## PRODUCT CHANGE NOTICE

### PCN Form (D4-E000-73)

**PCN#23-033****NOTIFICATION DATE: May 09, 2023****MODELS AFFECTED**

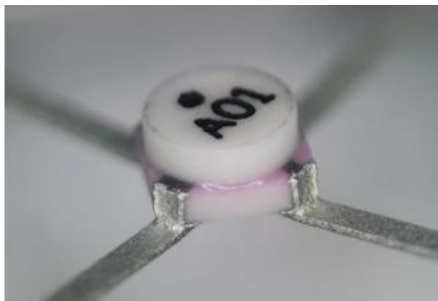
**EXTENT OF CHANGE:**

Change of Lid Seal epoxy to alternate qualified supplied material

**From:****To:****EFFECT OF CHANGE:**

No change to FIT (Dimensions) or FUNCTION (Performance)

Minor change to FORM (Appearance)
